**RE: Cypress Woods RV Resort PD
DCI2020-00002**

Enclosed please find responses to Staff's comments dated May 17, 2020. The following information has been provided to assist in your review of the petition:

CYPRESS WOODS RV RESORT PHASE 5 RECREATIONAL VEHICLE PLANNED DEVELOPMENT

MASTER CONCEPT PLAN

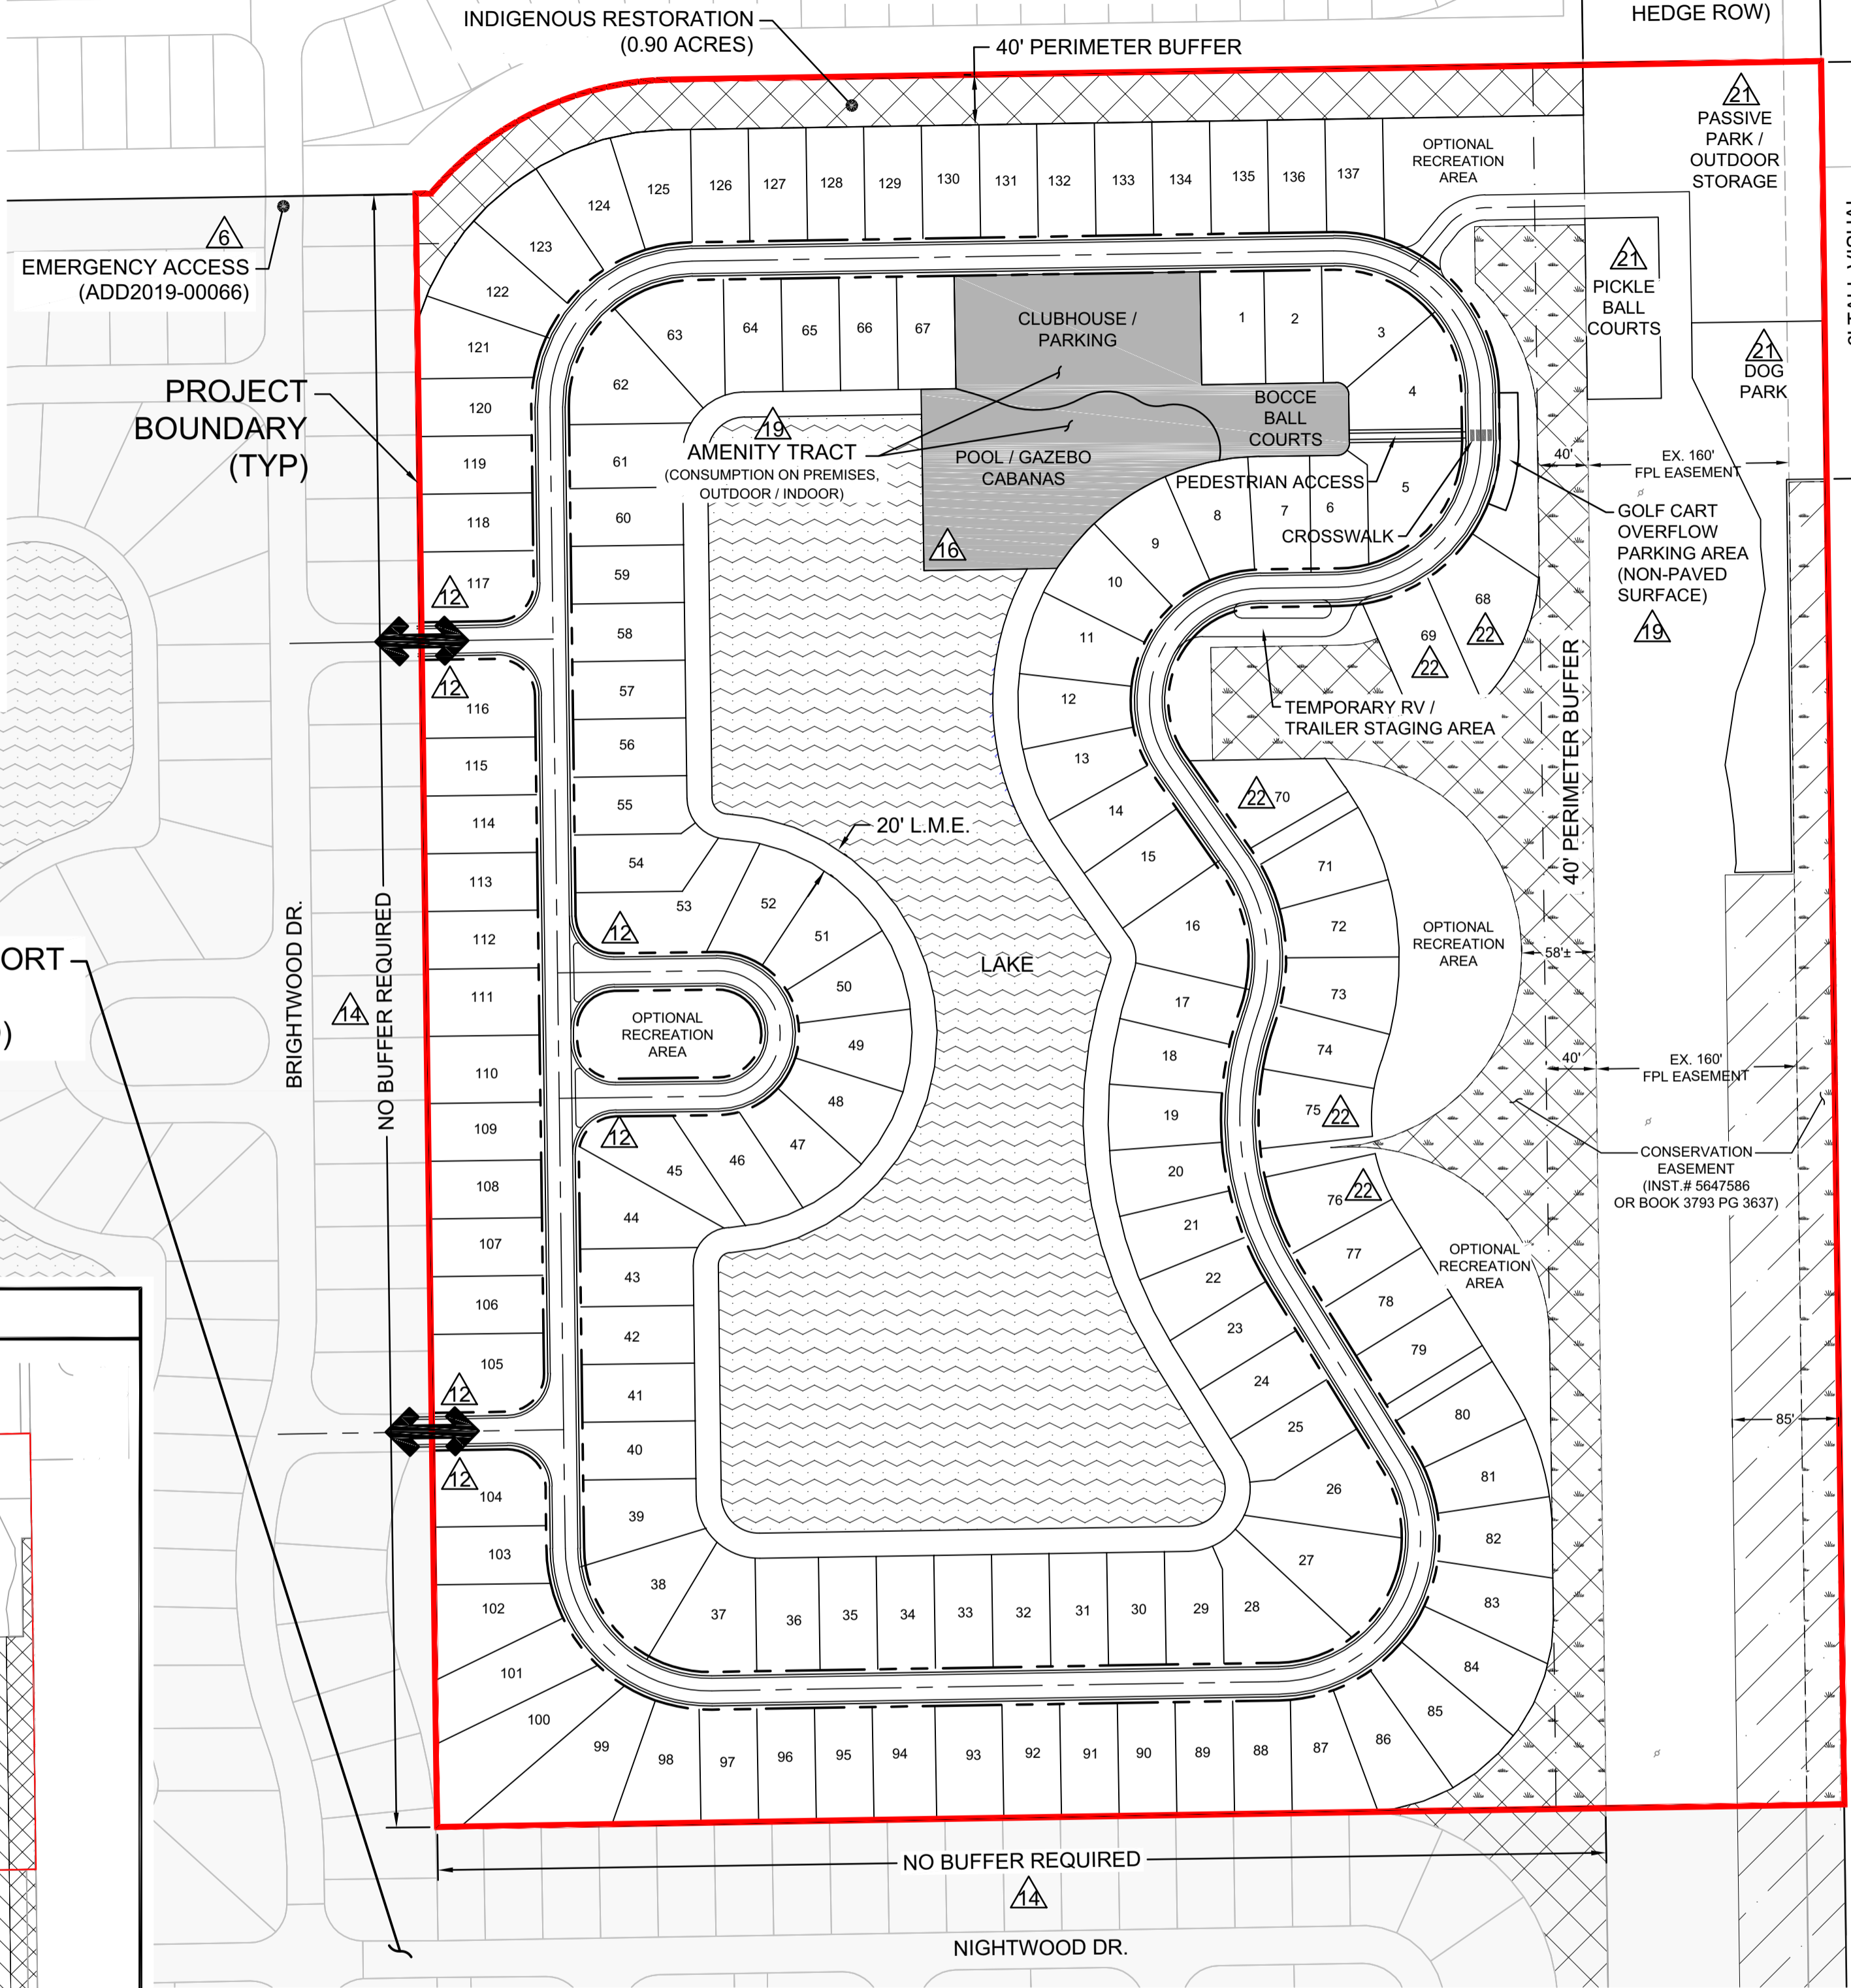
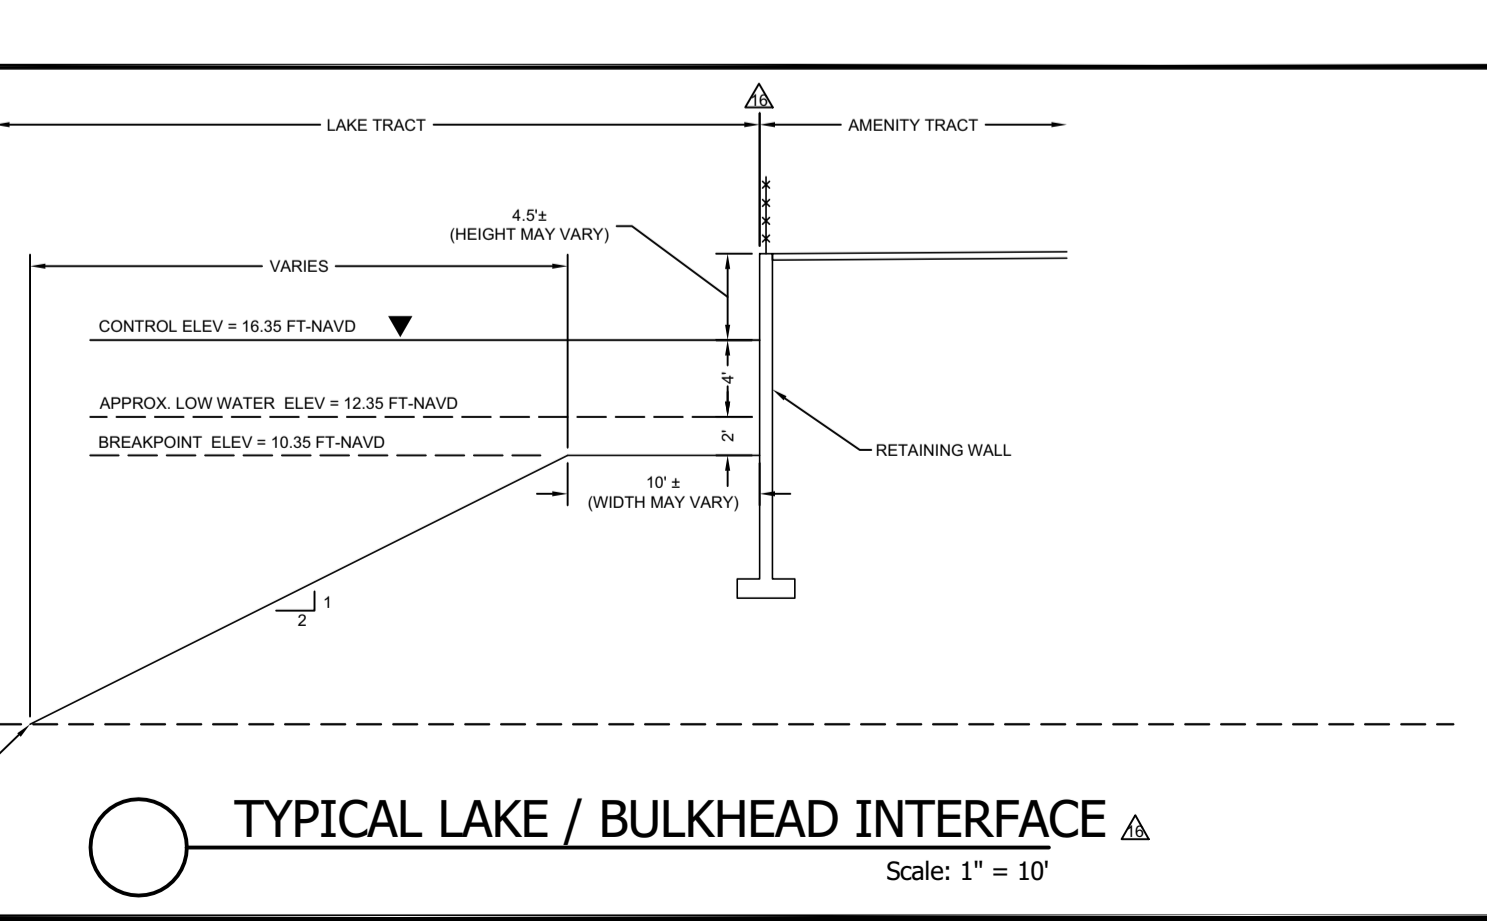
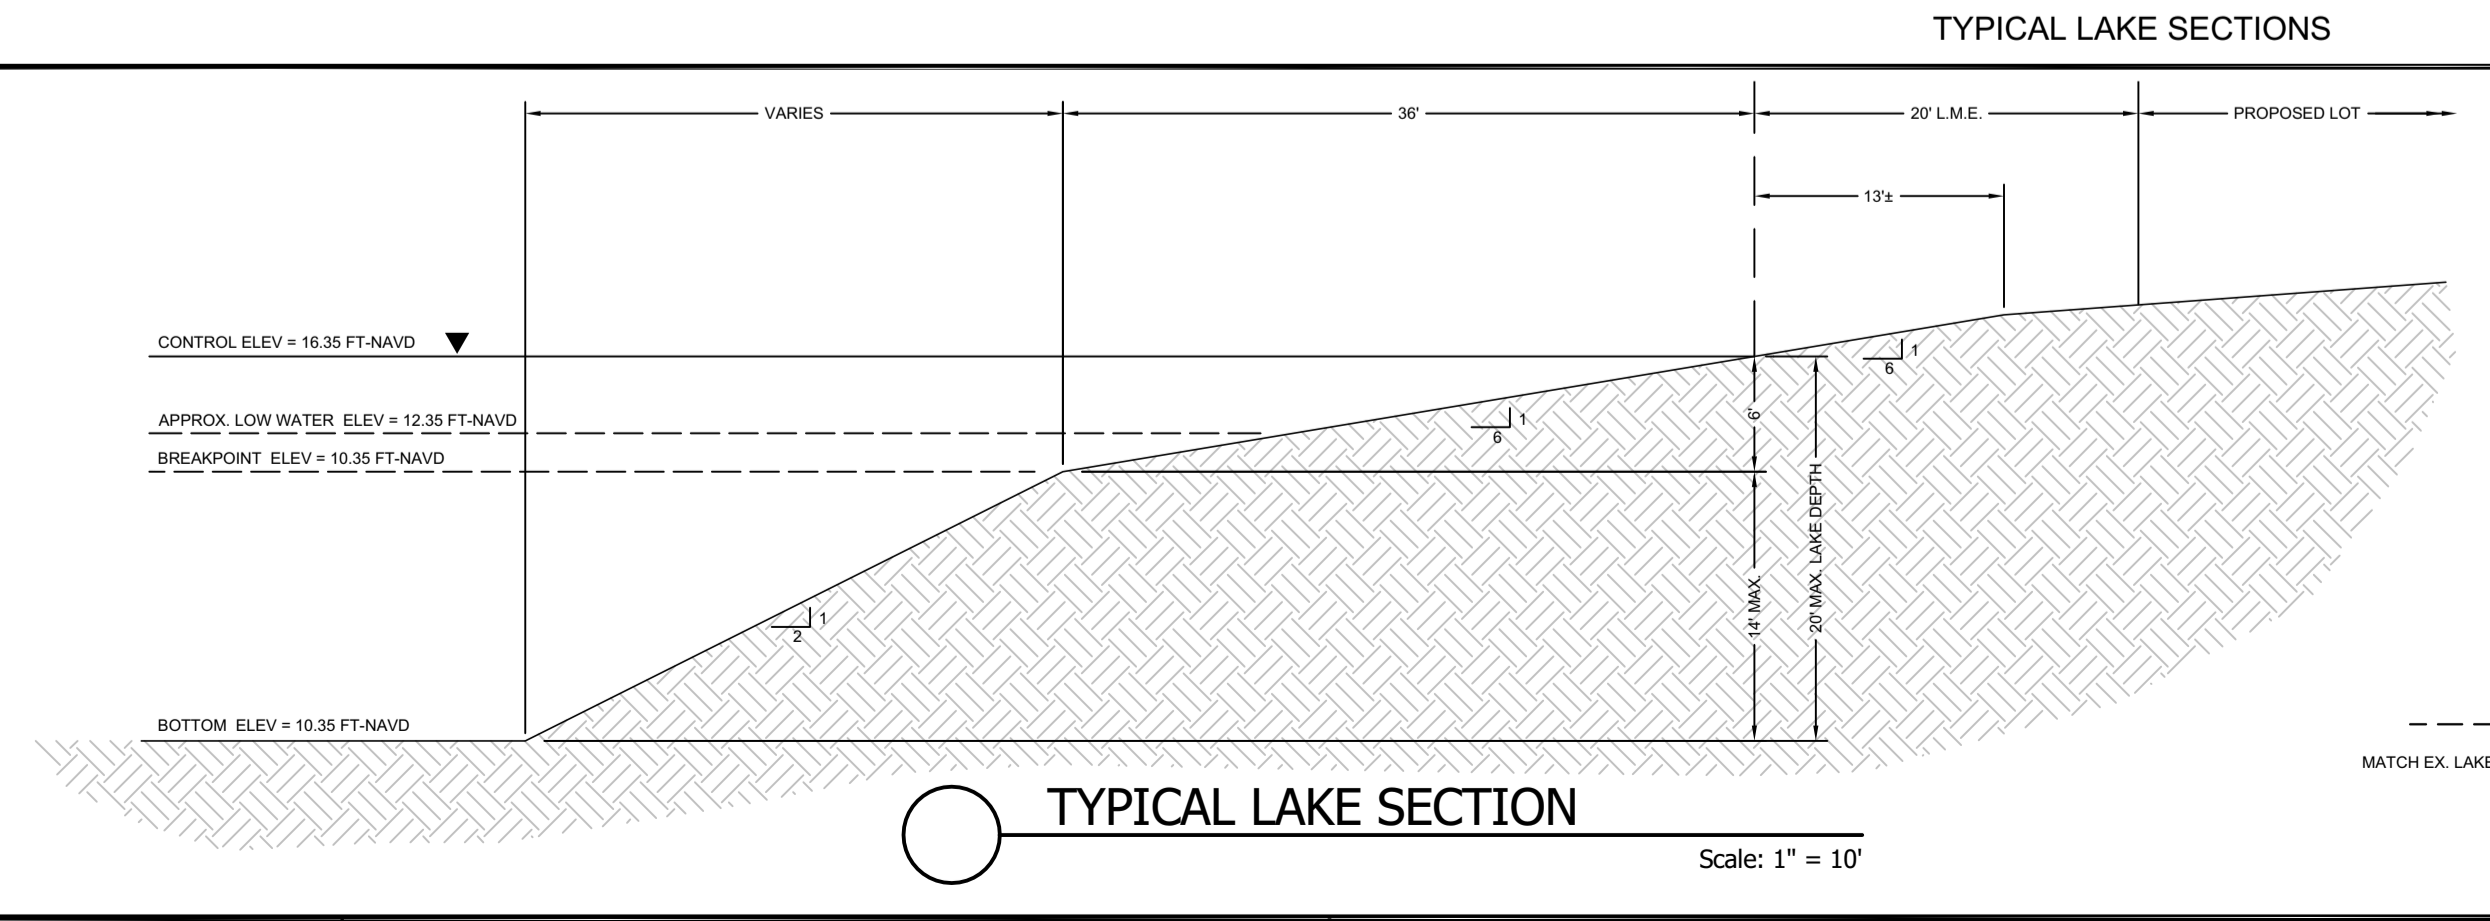
1. The applicant's justification doesn't address the single family residences zoned AG-2 to the NE which will have an unobstructed view of open storage, pickle ball courts and dog park. Additionally, the lots to the north will also have an unobstructed view. Please address the issue of off-site impacts caused by having no buffer and provide additional justification or measures to mitigate this concern.

- Deviation #21 must include a visual screen. LDC 939(b)(3) requires a 40-foot wide buffer around the entire boundary of the property and does not minimize or eliminate the buffer based on the abutting use. County staff will not approve no buffer for the accessory uses proposed along the north and northeast property lines. There must be a visual screen located outside of the FPL easement.

RESPONSE: Please refer to the revised Master Concept Plan attached. A 6' tall double hedge row has been provided on the east side of the FPL easement to provide a visual screen of the proposed recreational uses and storage area. Please note this area will not be used for RV storage. The intent is to store vehicle trailers and similar items. Thus, the 6' tall screen will adequate block views of the items stored.

RESPONSE: Please refer to the revised Master Concept Plan attached. A 6' tall double hedge row has been provided on the east side of the FPL easement to provide a visual screen of the proposed recreational uses and storage area. As noted above, this area will not be used for RV storage. The intent is to store vehicle trailers and similar items. Thus, the 6' tall screen will adequately block views of the items stored.

2. Please clarify deviation #3 call out as it is shown in the ROW in several locations on the MCP. The deviation refers to a turn out radius but is shown in areas where it would not be applicable.

RESPONSE: Please refer to the revised Master Concept Plan. References to Deviation 3 have been removed.

- Revise the MCP to state that a 40-foot buffer around the entire perimeter, excluding perimeter boundaries that abut adjacent RVPD or RV zoned property. Currently, the eastern property line states that a buffer is not required and is not in compliance with LDC 34-939(b)(3).

RESPONSE: The eastern buffer has been revised to depict the location where the RVPD 40-foot buffer is provided, and where the alternative screening is proposed per Deviation 21.

- The indigenous open space credit chart depicts wetland habitat being calculated for credit. LDC 10-415(b) only allows indigenous credit for uplands. Please see applicant's FLUCCS map versus the indigenous credit hatching. Revise indigenous open space credit chart and ensure open space is being met in accordance with Z-11-021.

RESPONSE: The table on MCP Sheet 4 is applicable to the overall RVPD and replicates the credits approved as part of Z-11-021 for Phases 1 through 4. No changes to the preserve acreages and credits for Phases 1-4 is proposed.

The Table has been updated for Phase 5 indigenous acreages only. The table demonstrates the proposed reduction in preserve area within Phase 5 of 1.8 acres of actual preserve. Per footnote 1 under the table, the acreages reflect revisions within the Phase 5 Development boundary, and also corrects calculation errors in the previously approved MCP. Footnote 2 further clarifies that the Applicant is not seeking indigenous credit for any preserve areas in Phase 5.

The proposed indigenous acreage still exceeds the minimum required preserve acreage for the overall RVPD by 4.79 acres (30.3 acres required vs. 35.09 acres provided).
